Office Action Summary

10/573,003

MERLO ET AL.

DETAILED ACTION

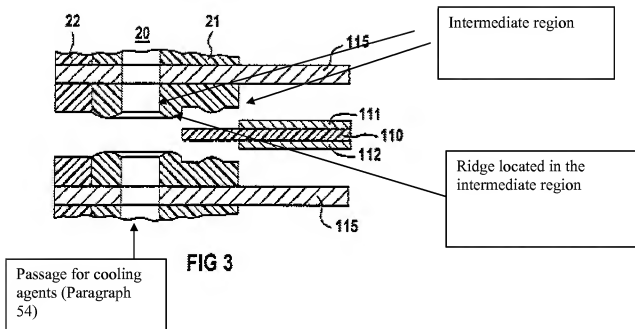
Faïta modified by the Applicant fail to disclose the edge of the membrane in the intermediate region defined by the boundary of the center hollow portion in the gasket and the circumference of the passage openings. Baldauf et al. disclose a fuel cell stack with a gasket and a membrane. Baldauf discloses the perimeter of the membrane (110) in the intermediate region (see figure below)

It would have been obvious to one of ordinary skill in the art at the time of the invention in include the seals of Baldauf in the fuel cell system of Faïta modified by Admitted Prior art because this would prevent the interaction of the fluids traveling through passages with the membrane.
